SERVICE BULLETIN

Bulletin No. 623A

Revised 8/1984

SUBJECT: Inspection of impulse coupling cam assemblies.

Figure 1

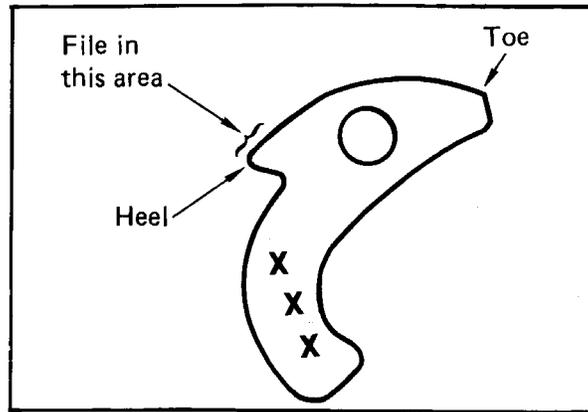
1. Following published procedures remove the magneto from the engine.
2. Place the magneto in a suitable work stand with the impulse coupling facing up.
3. Use finger pressure to push inward on the toe (see figure 1) of each flyweight so that the flyweight heel protrudes outward.
4. Using a fine #1, double cut, 1/2 inch wide file, at least 3/32 inch thick, pass the file across the heel of the flyweight attempting to remove material. (See figure 1). If the flyweight has been properly heat treated the file will "glide" smoothly over the heel of the flyweight, removing no material. If the flyweight is not properly heat treated (soft), the file will not "glide" easily across the surface of the flyweight heel, and material will be removed.

12. A new method of marking is being implemented to permanently identify heat treated cam assembly flyweights. See figure "1" for location. Pending consumption of current inventory, there will be a mixture of assemblies identified by the following methods.

1. Original method ----- Yellow paint (Dykem or Lacquer) on the heel of each flyweight.
2. New method ----- Stamped numbers as indicated in figure "1" on each flyweight.

5. If an improperly heat treated (soft) flyweight is found, immediately remove and replace the cam assembly and/or the impulse coupling assembly following procedures in the magneto overhaul instructions, and paying strict attention to notes and cautions.
